Avolites Ltd.
Engineering Change Notice

Title	D4 EZ DMX 1201-1910A POWER MODIFICATION
ECN Number	ECN 163
Equipment	D4 VISION & ELITE
Author	ALMAS ALI
Drawing Number	
Date	24-10-06

EZ DMX BOARD D/DRIVE CONNECTOR (POWER)

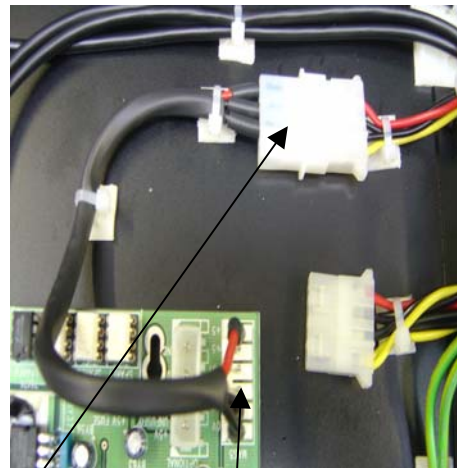
Reason for ECN	HARD WIRE POWER TO EZ DMX BOARD
Special Parts required	ATX POWER EXTENSION CABLE
Special Tools required	SIZE 1 POZI DRIVE & SOLDERING IRON

REMOVE POWER FROM EZ DMX BOARD (D/DRIVE PLUG) AND CONNECT ATX POWER EXTENSION CABLE CUTTING OFF FEMALE CONNECTOR IF NOT SUPPLIED BY AVOLITES & SOLDER BARE WIRES TO 6 WAY LOCKHEADER (MAS.5) RED TO . 5V 2X BLK TO. 0V SEE BOARD MARKINGS
